Product hierarchy no. *				Part no.	SBU	Type / Description	Customer part no.
SBU	PG	PUG	Type				
02	005	016	0000001210	See list below	Power Entry Module	6762 (snap-in)

Change of approval markings from UR and CSA to the combined cURus on the product socket.

Product Change Notification					PCN 6762 (snap-in)		
owner	creation date	release date	released by	change order no	rev	page	
huberth	25.09.2019	01.10.2019	limachcl	2018434	A	1 of 1	D10-039-976

3 Detailed description of change

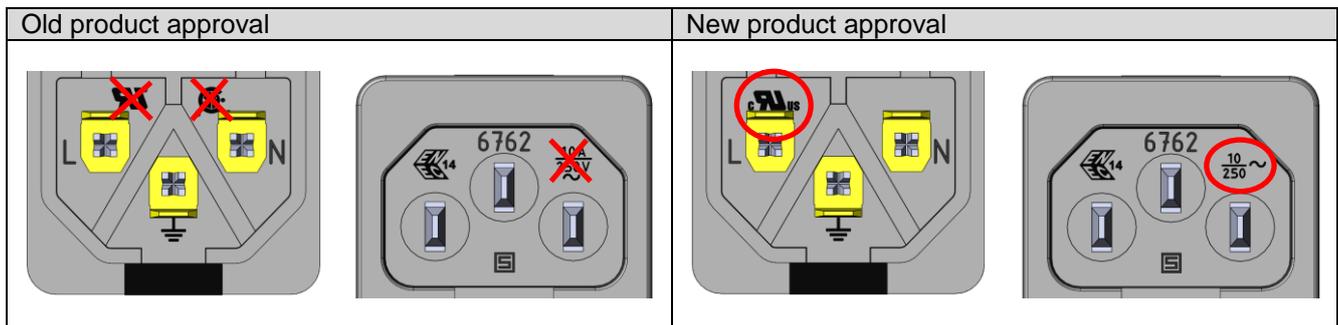
Form	Yes	Socket new with cURus approval marking
Fit	No	-
Function	No	-
Manufacturing	No	-
Label	No	-
Packaging	No	-
